1 **REVISED PER ADDENDUM No. 1 DATED APRIL 21, 2011**

BRIDGE NO. 12E0003
POST MILES 33.0

RETAINING WALL No. 2
GENERAL PLAN

BIDWELL PARK VIADUCT (WIDEN)
GENERAL NOTES

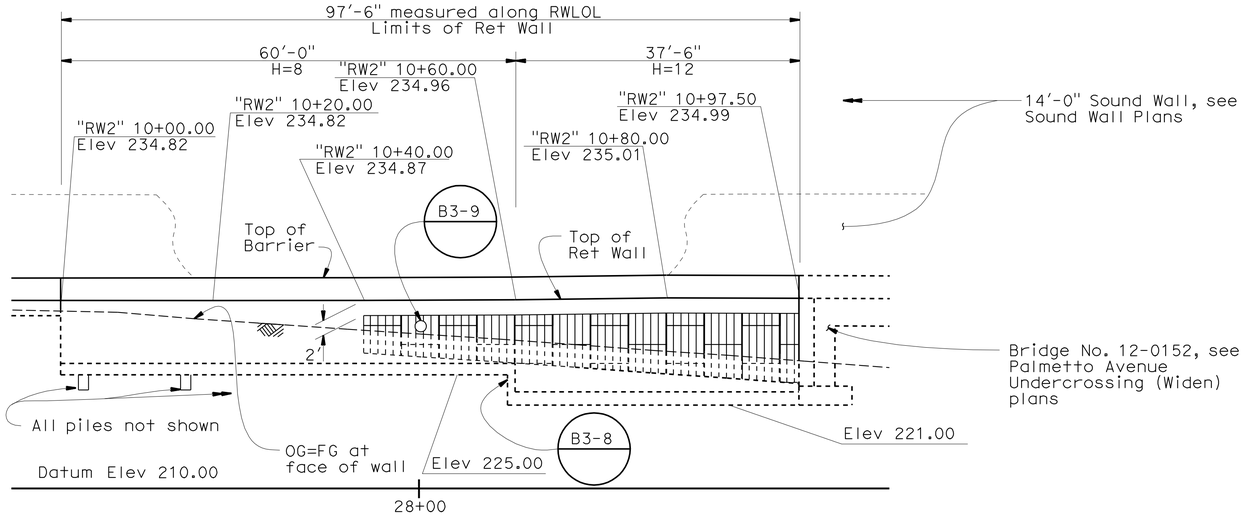
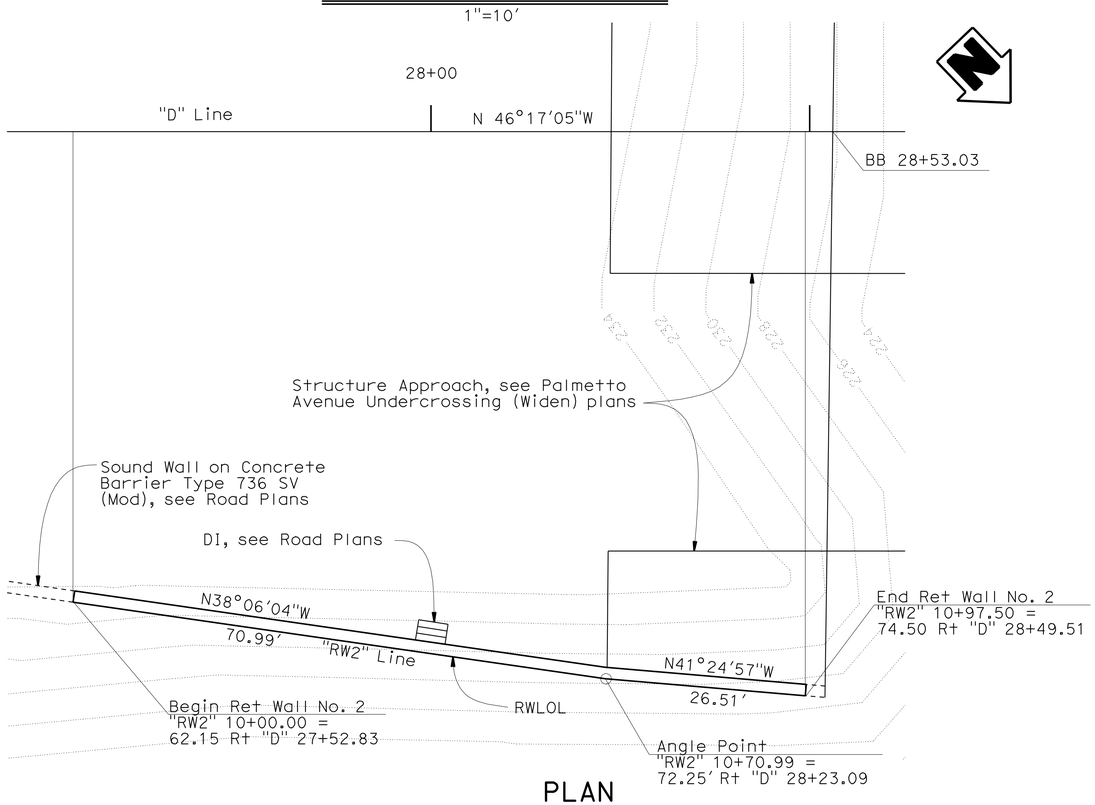
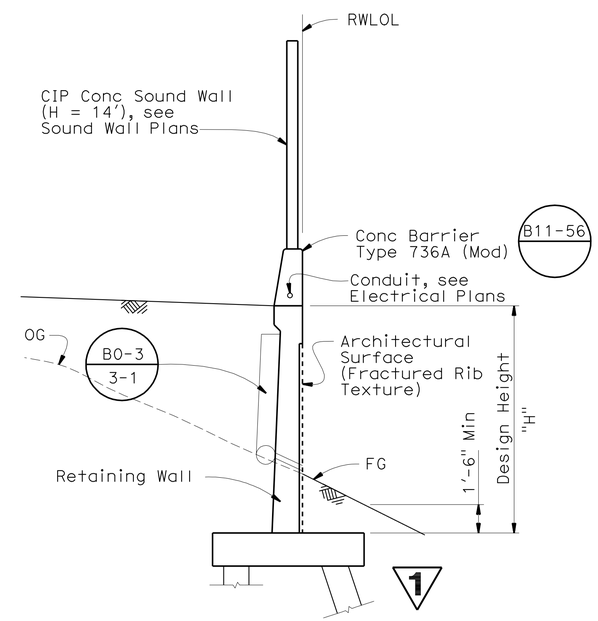
STRUCTURE EXCAVATION (RETAINING WALL)	226	CY
STRUCTURE BACKFILL (RETAINING WALL)	244	CY
FURNISH STEEL PILING (HP 14 X 89)	519	LF
DRIVE STEEL PILE (HP 14 X 89)	19	EA
STRUCTURAL CONCRETE, RETAINING WALL	92	CY
ARCHITECTURAL SURFACE (FRACTURED RIB TEXTURE)	362	SQFT
BAR REINFORCING STEEL (RETAINING WALL)	13,685	LB
CONCRETE BARRIER (TYPE 736A MODIFIED)	98	LF

RETAINING WALL No. 2
DETAILS No. 1

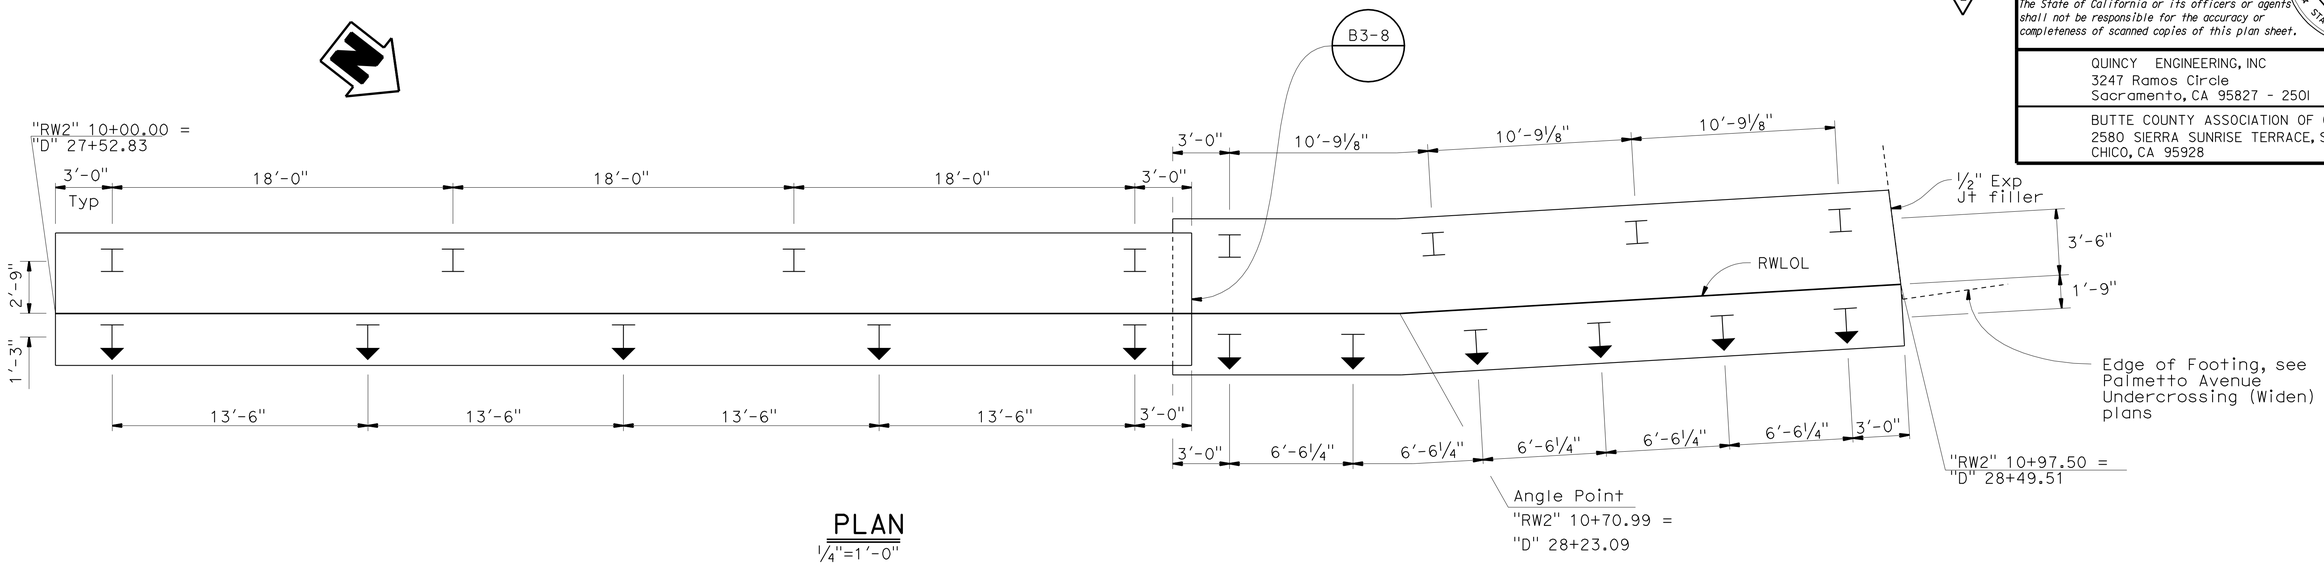
LOCATION	PILE TYPE	DESIGN LOADING (LFD)	NOMINAL RESISTANCE		DESIGN TIP ELEVATION	SPECIFIED TIP ELEVATION
			COMPRESSION	TENSION		
10+00.00-10+60.00	HP 14 x 89	123 kips	164 kips	35 kips	199.0 (1), 215.0 (2) 200.0 (3)	199.5
10+60.00-10+97.50	HP 14 x 89	105 kips	140 kips	43 kips	194.5 (1), 207.5 (2) 195.0 (3)	194.5

RETAINING WALL No. 2
DETAILS No. 2

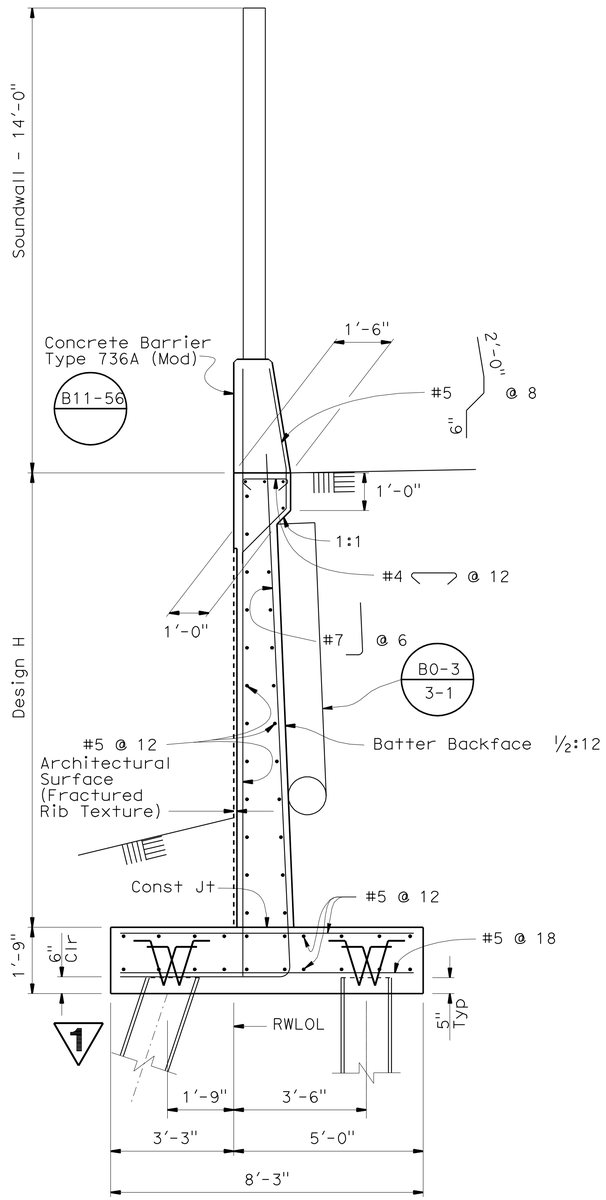
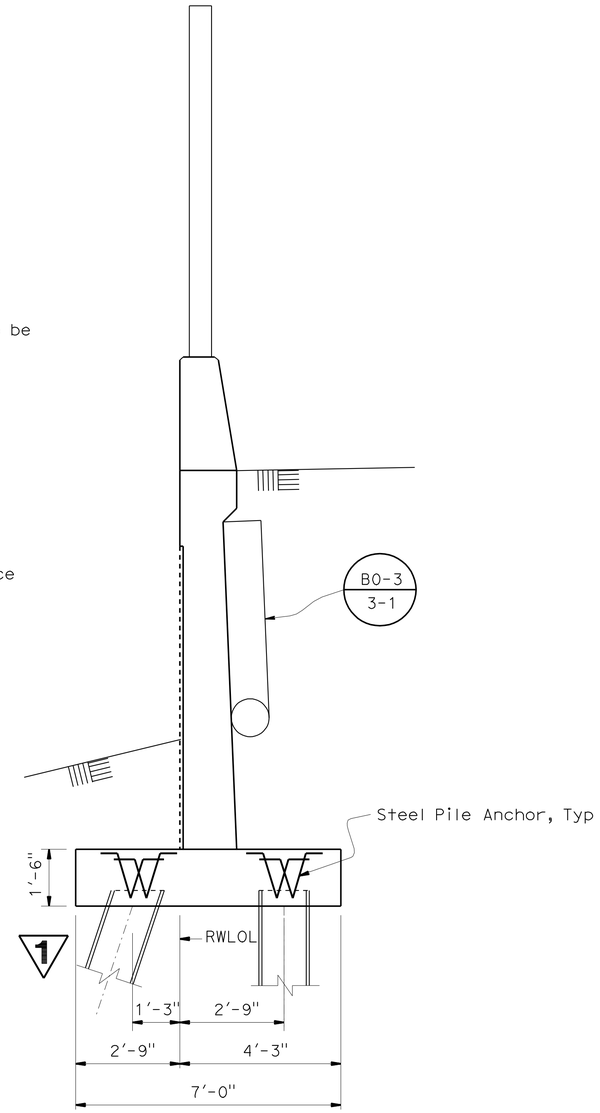
Loading Case:
Level Ground with 240 psf live load surcharge and 14' CIP sound wall.
Seismic Load = 0.57 Dead Load
Wind Load = 33 psf
Dead Load of Soundwall = 1,100 lb/lf
Dead Load of Barrier = 560 lb/lf

BIDWELL PARK VIADUCT (WIDEN)
TYPICAL SECTION No. 1

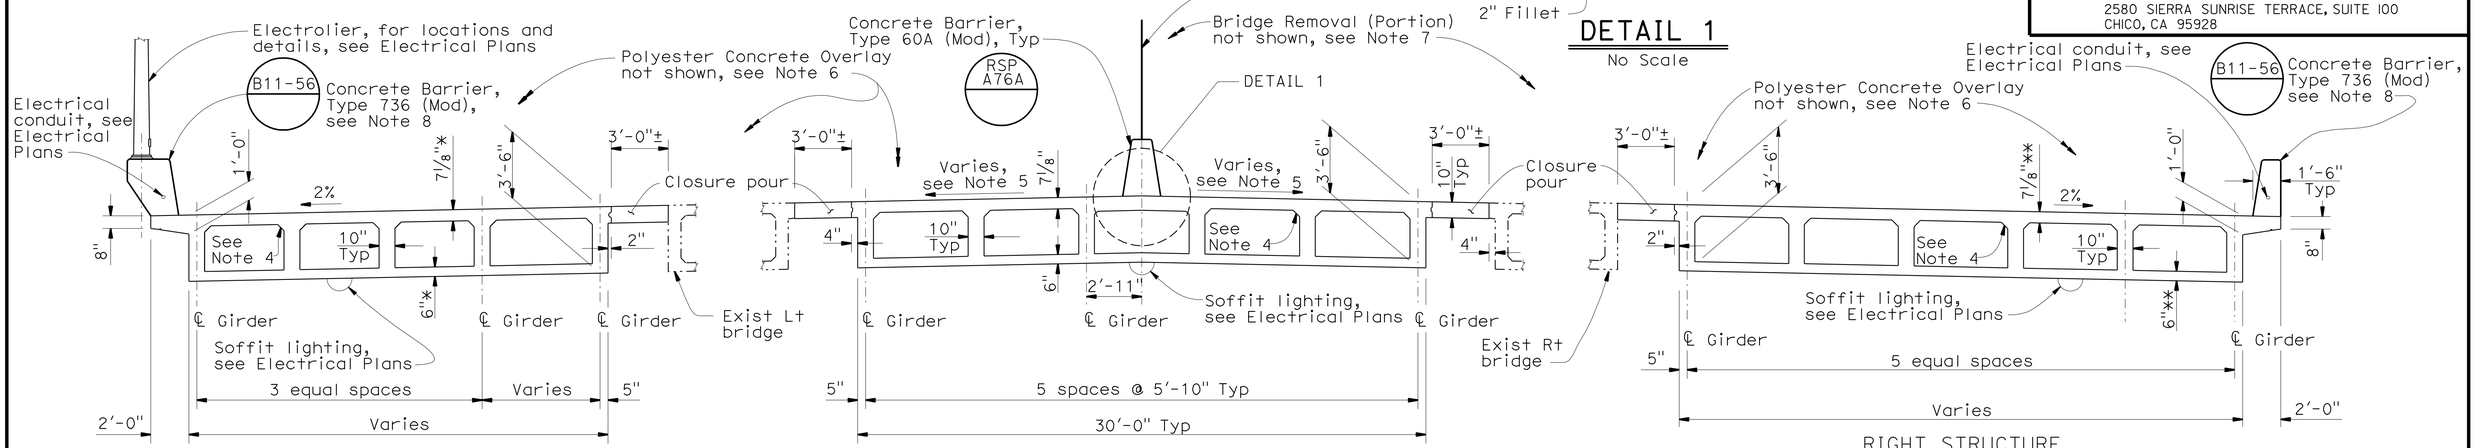
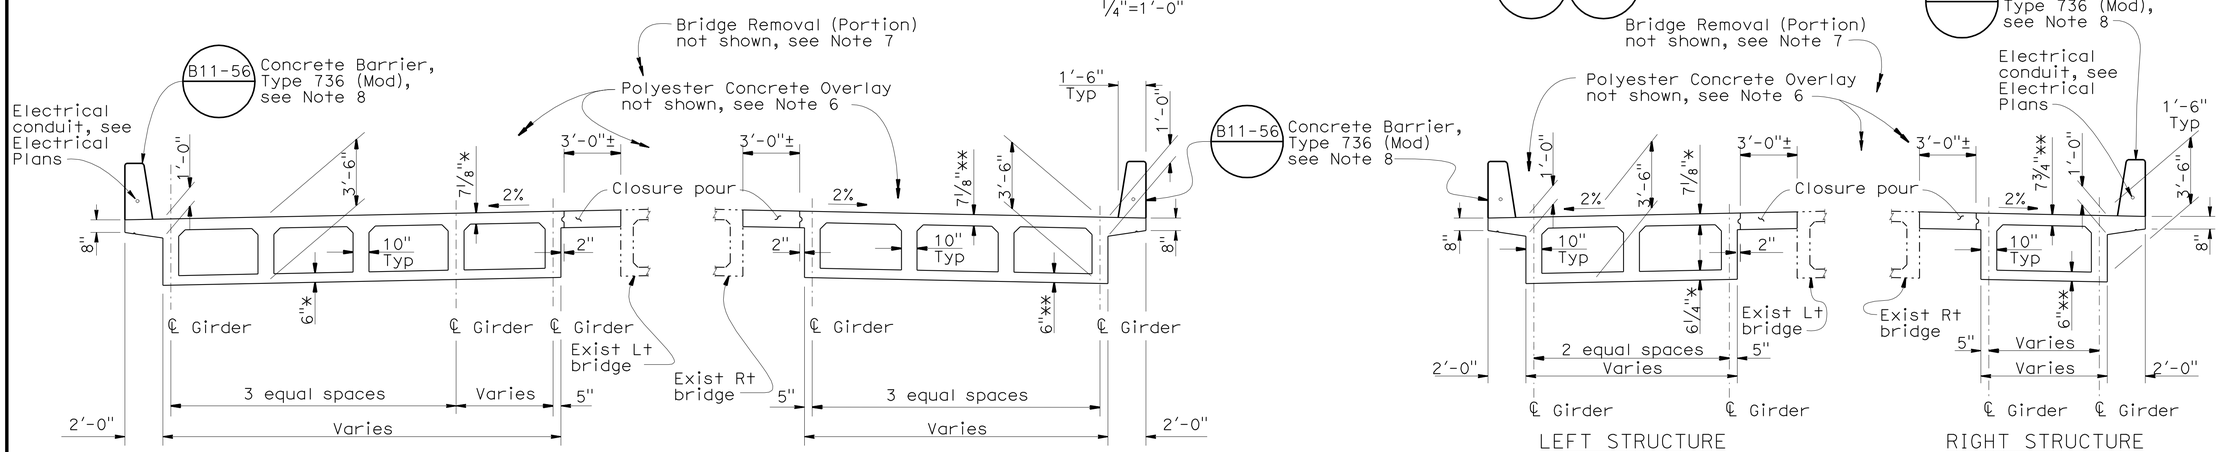
6. Polyester Concrete Overlay not shown. Prepare Concrete Bridge Deck Surface and overlay full deck width (new and existing structures including approach slabs) with 3/4 " minimum and varies Polyester Concrete. For limits, see "Construction Sequence No. 3" sheet.

BIDWELL PARK VIADUCT (WIDEN)
TYPICAL SECTION No. 2

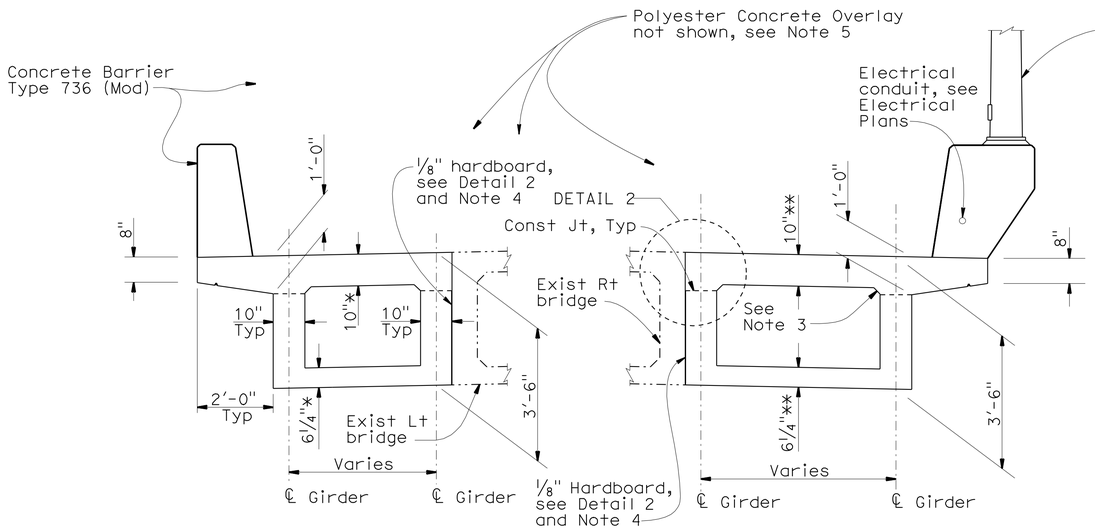
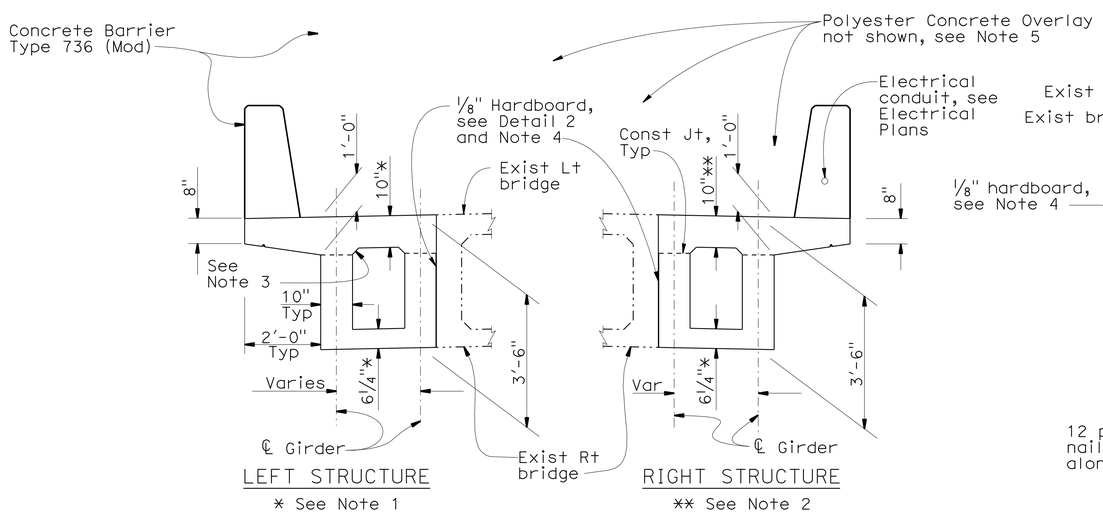
5. (1) Polyester Concrete Overlay not shown. Prepare Concrete Bridge Deck Surface and overlay full deck width (new and existing structures including approach slabs) with 3/4" minimum and varies Polyester Concrete. For limits, see "Constuction Sequence No. 3" sheet.

BIDWELL PARK VIADUCT (WIDEN)
TYPICAL SECTION No. 3

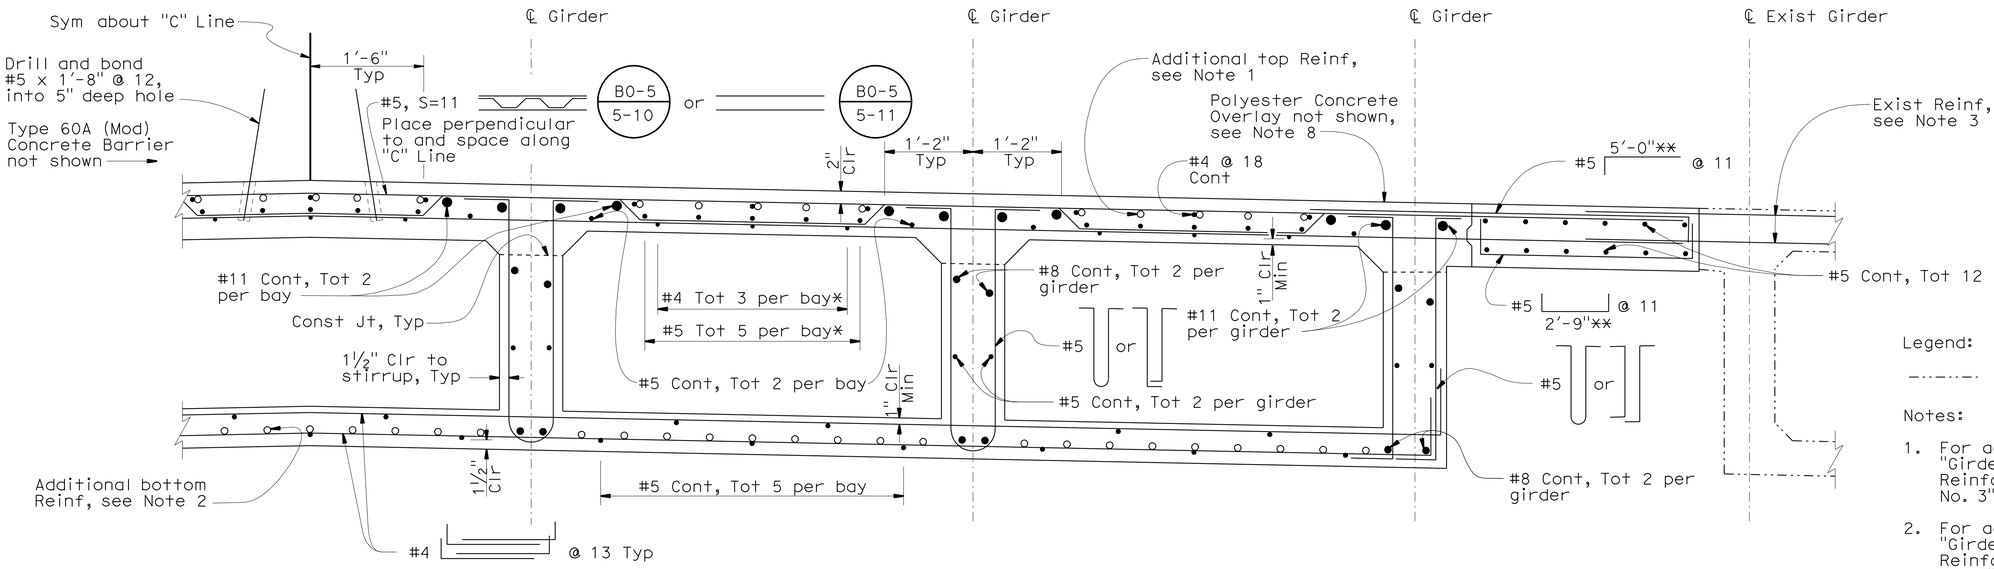
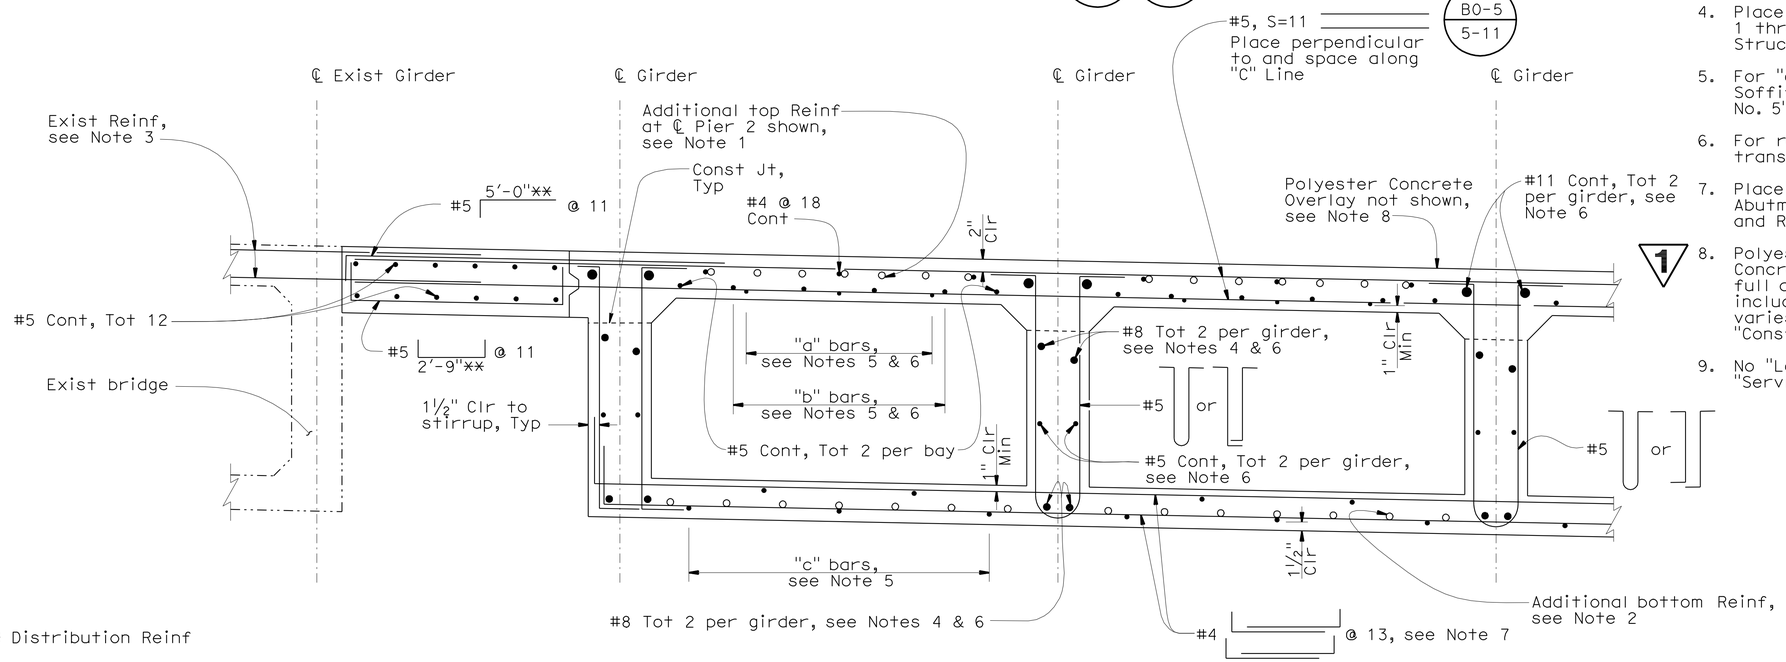
7. Place #4 transverse soffit reinforcement from Abutment 1 to Pier 11 of both Left Structure and Right Structure.
8. Polyester Concrete Overlay not shown. Prepare Concrete Bridge Deck Surface and overlay full deck width (new and existing structures including approach slabs) with ¾" minimum and varies Polyester Concrete. For limits, see "Construction Sequence No. 3" sheet.
